AP - 477 Congress St.

APPLICATION FOR PERMIT

Re: Alterations to the
Casco Bank & Trust Co.
477 Congress Street

Examination of plans filed with application for permit for alterations to section of building at the above named location discloses variances from and questions as to compliance with Building Code requirements as indicated below. Before a permit can be issued it is necessary that information indicating compliance with requirements be furnished for checking and approval. Details in question are as follows:

By FIRM SEAMAN ASSO.
FOR JERSEY BLDG BUREAU & HENRY
477 CONGRESS ST.
7th FLOOR

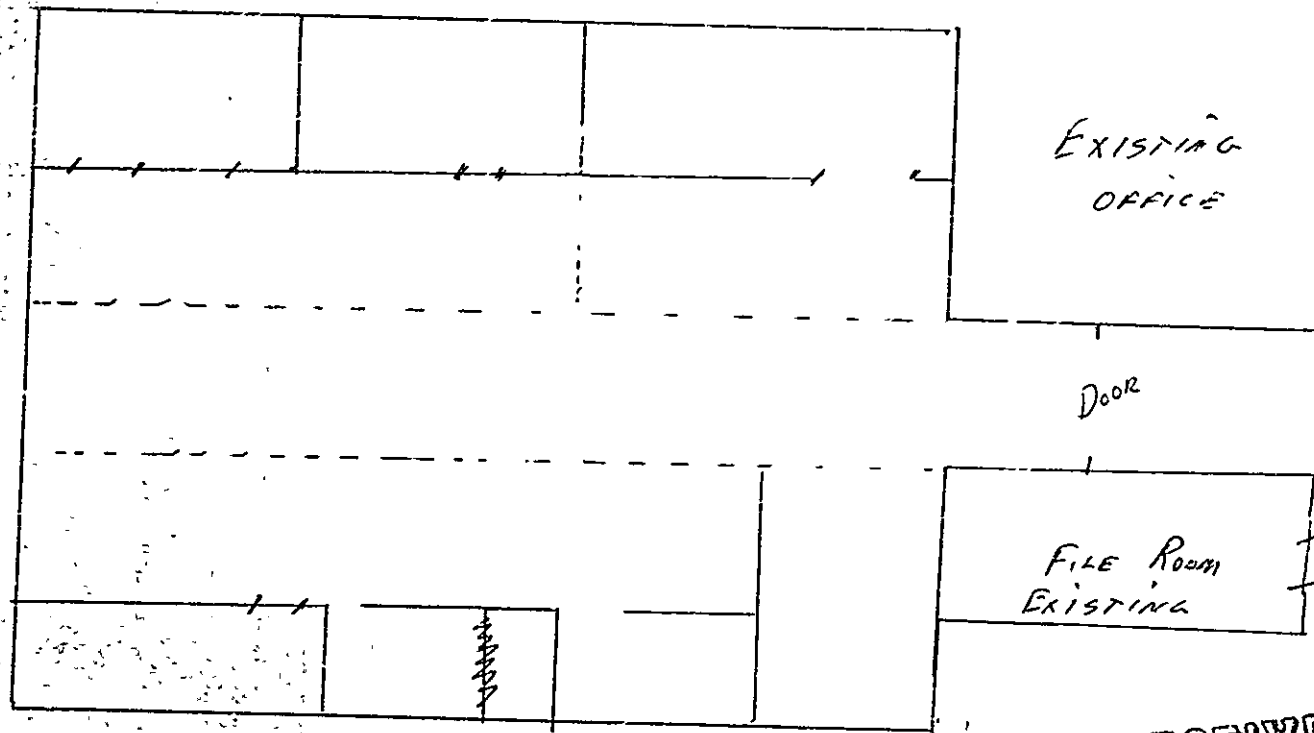
REMOVE WALL SHOWN BY DOTTED LINE
